1. SUBMITTAL TYPE: (Is this a resubmittal? Yes ☐ No ☒)			
Deferred Submittal ☐	Addendum Number: 01	Revision Number:	CCD Number: Category A ☐ or B ☐
2. PROJECT INFORMATION:			
School District/Owner: San Beranrdo City USD		DSA File Number: 36 H7	
Project Name/School: Indian Springs HS - Health Center		DSA Application Number 04 123900

ADDENDUM NO. 1

Indian Springs High School – Health Center

DSA #04-123900 FILE #36-H7 RCA Project No. 1-78-50

ROOM # 118 - NURSE'S STATION SCALE: 1/4" = 1'-0" 19

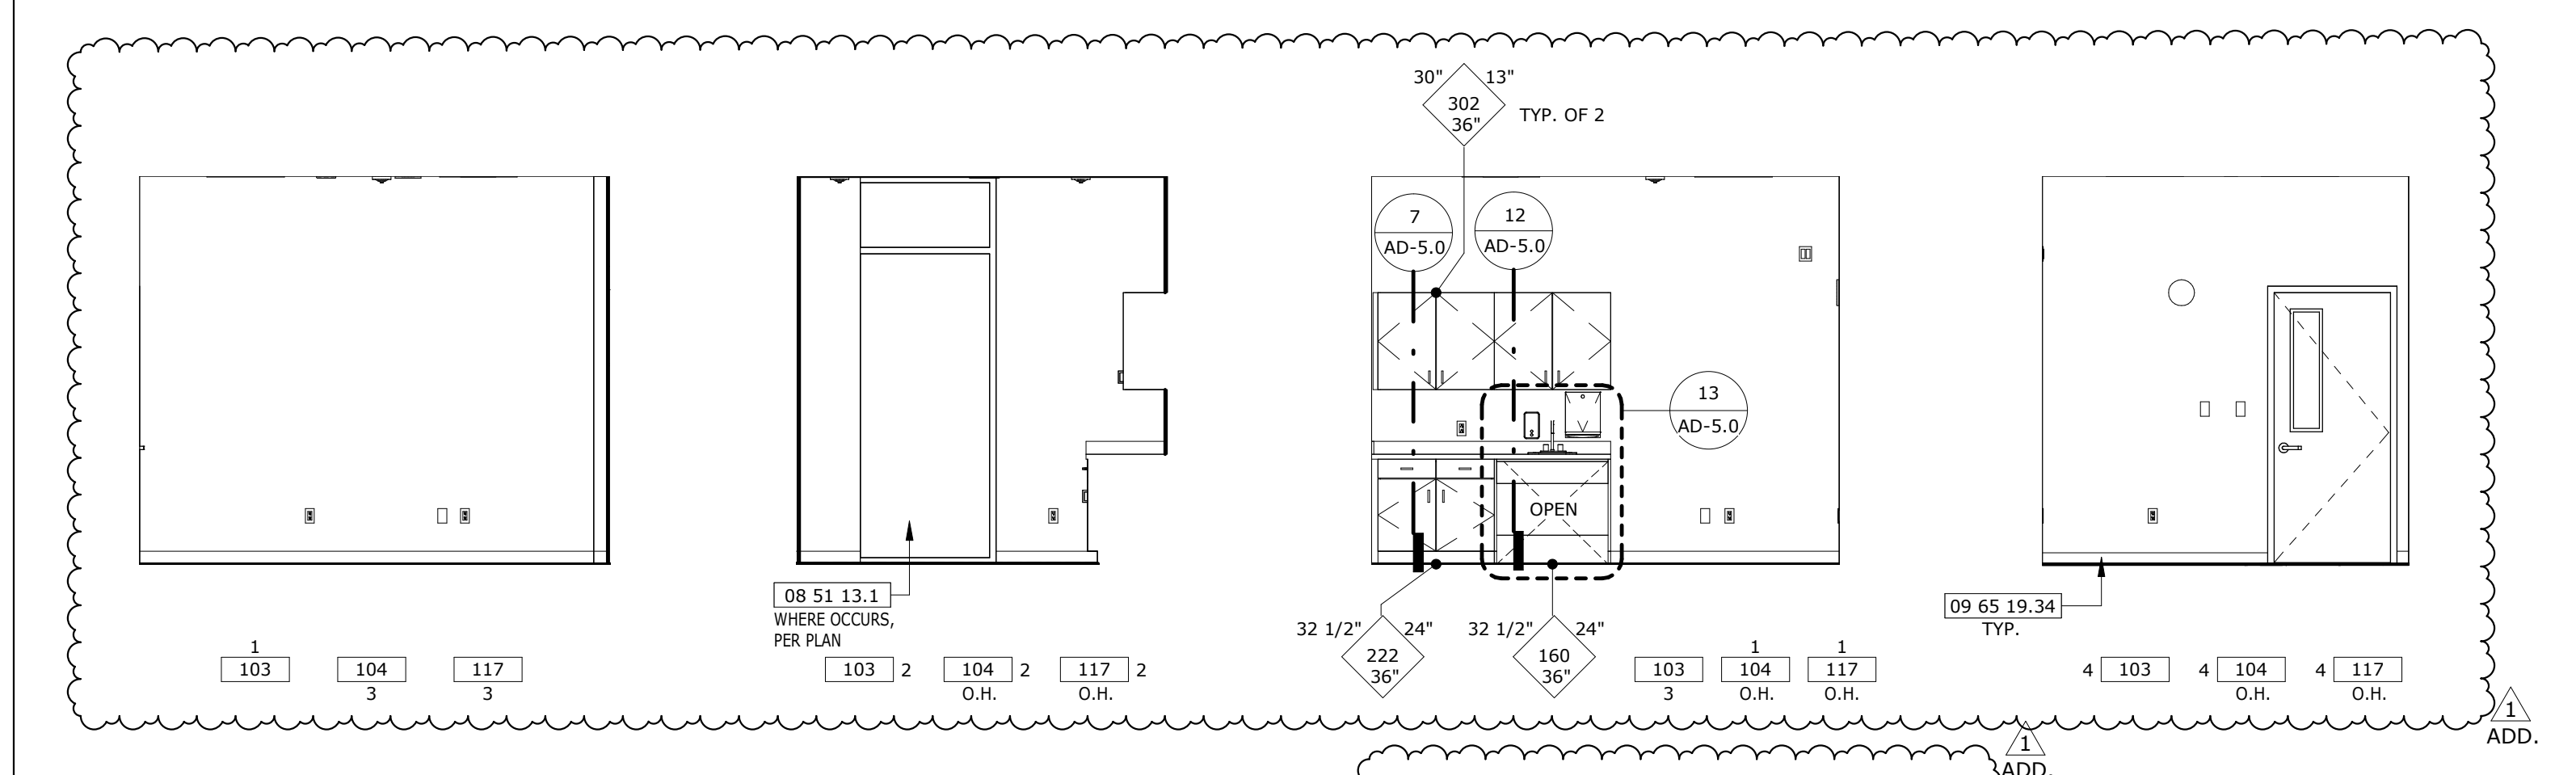
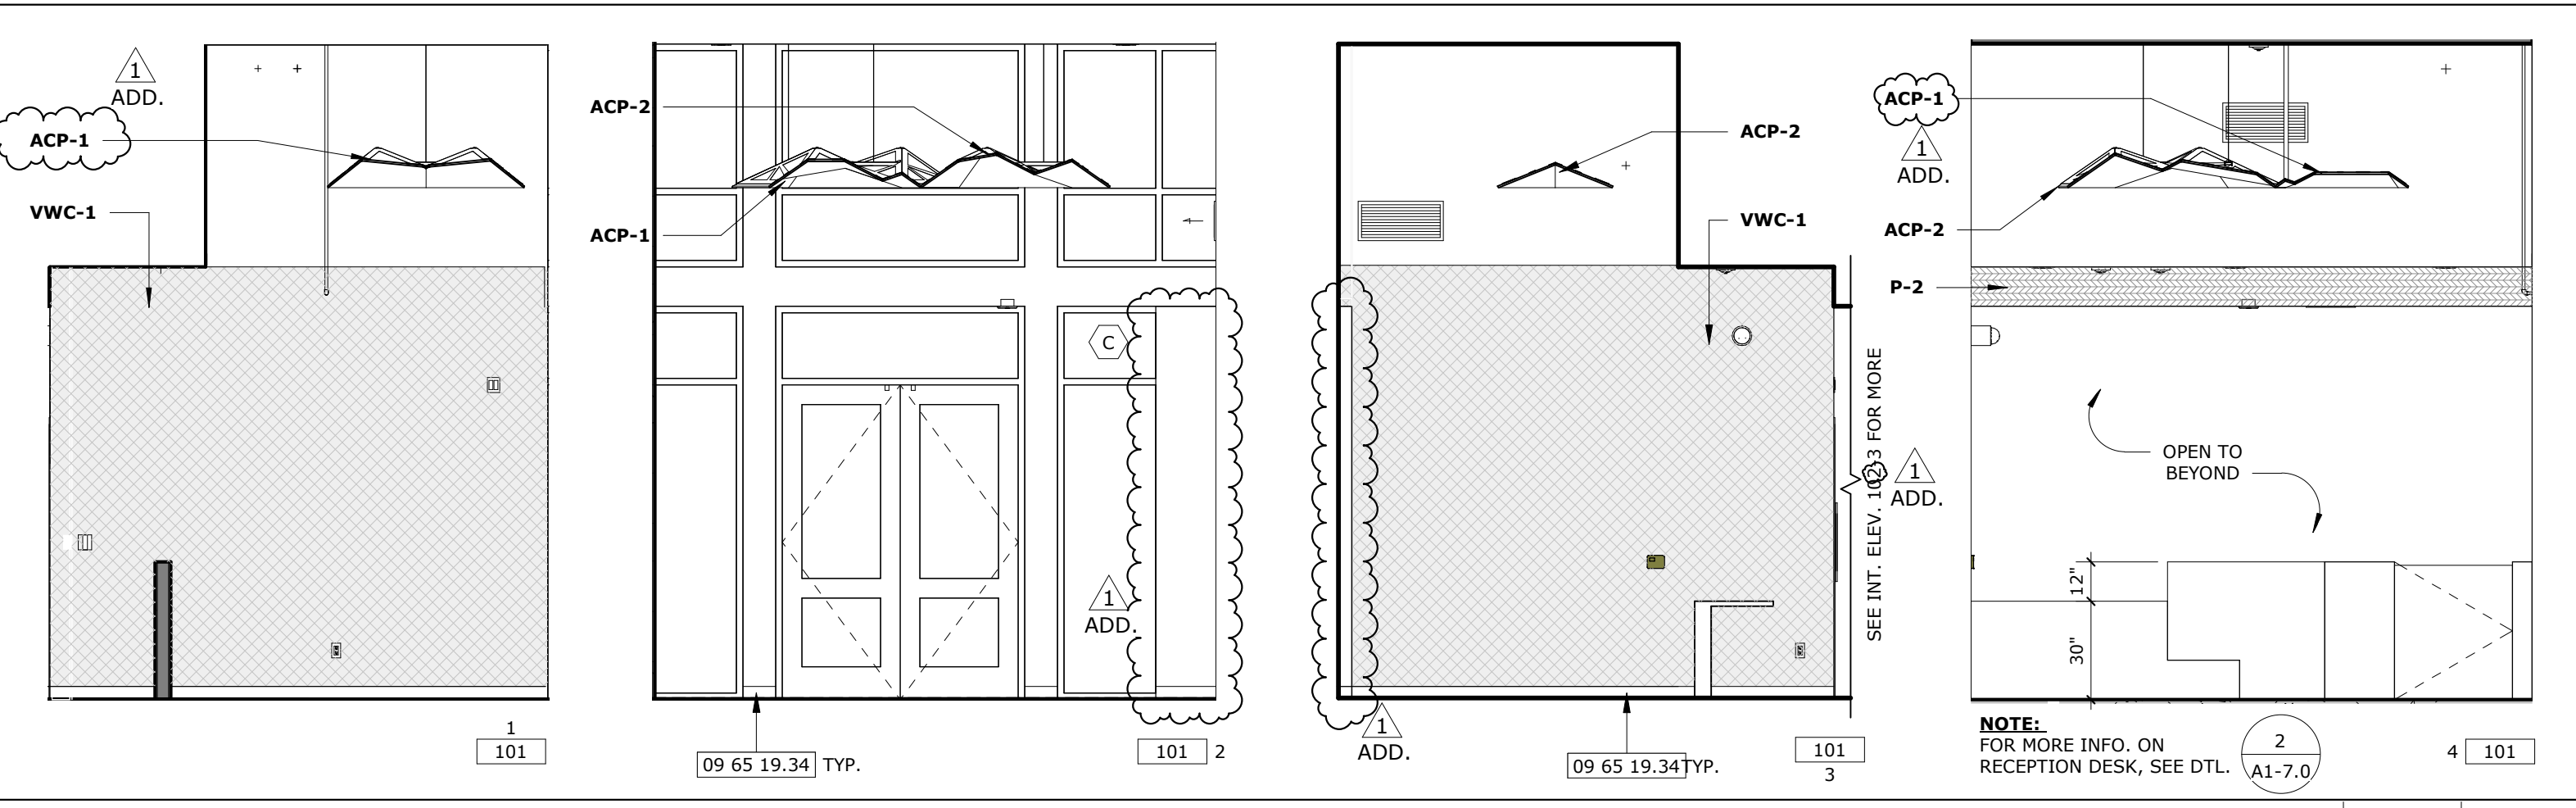
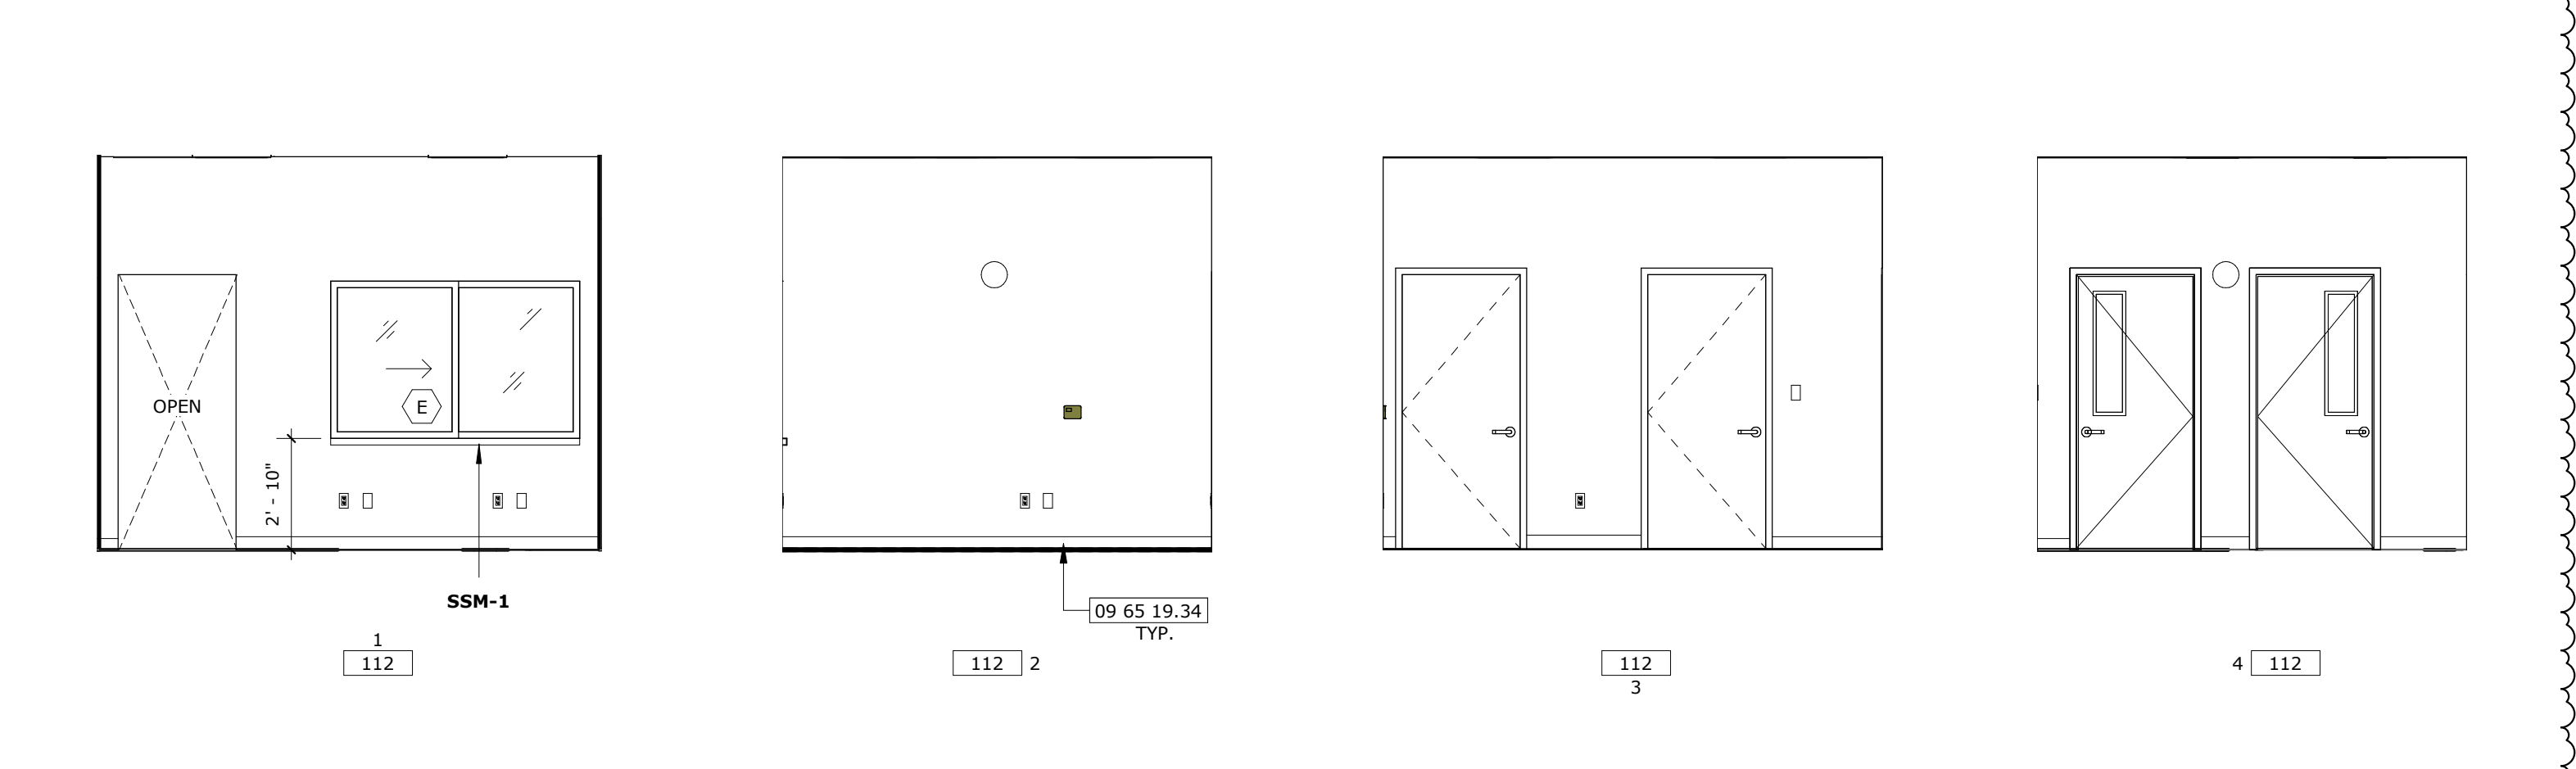
1.14.1 Replace Sheet A1-7.0 and revise per clouded areas & items listed below:
 (a) Detail 1, revised to reflect new restroom location on revised floor plan layout

(b) Detail 2, reduced size of Lobby Reception Desk
 (c) Removed Detail 3, no longer applies to project
 (d) Detail 5, revised to reflect the revised floor plan layout

- Item No. 1.15 Reference Sheet A1-7.1 – INTERIOR ELEVATIONS
1.15.1 Replace Sheet A1-7.1 and revise per clouded areas & items listed below:
 (a) Revised Interior Elevations to reflect the revised floor plan layout
